RESPONSES TO COMMENTS

Waste Discharge Requirements Order R7-2024-XXXX

Coachella Valley Water District

Water Reclamation Plant No. 10

Tentative Order, Attachment B—Maps and Facility Diagrams,
Figure 1—Map with Facility Location, p. 55)

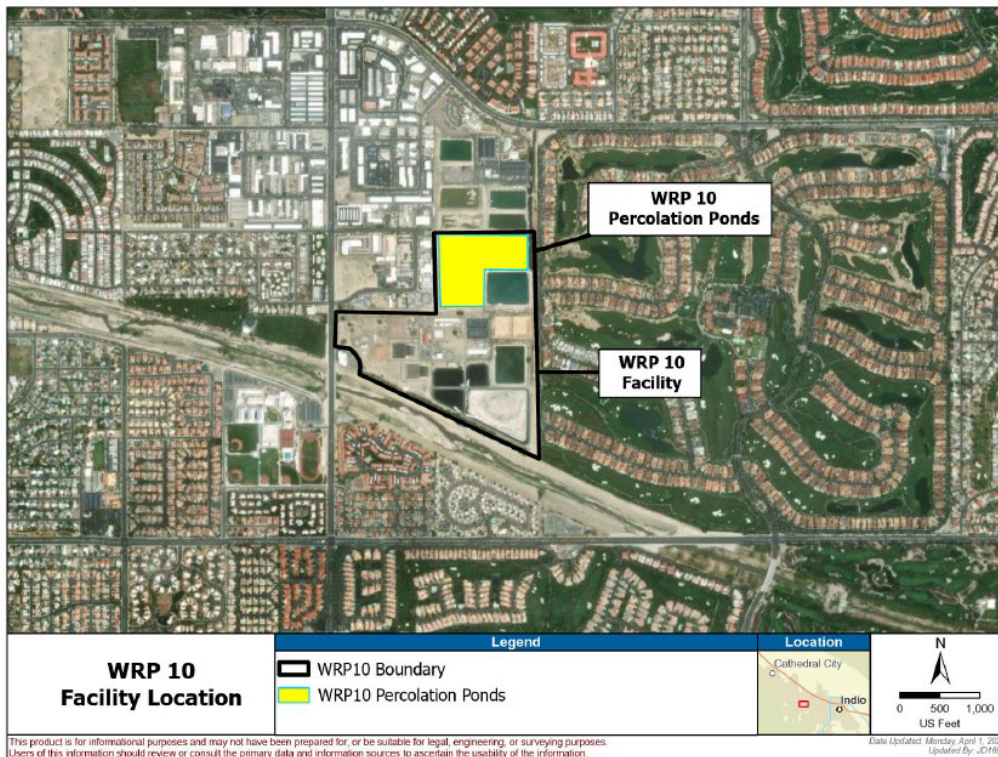
Substitute Figure 1 with the updated map below that omits the Phases 1-2 of the Palm Desert GRP.
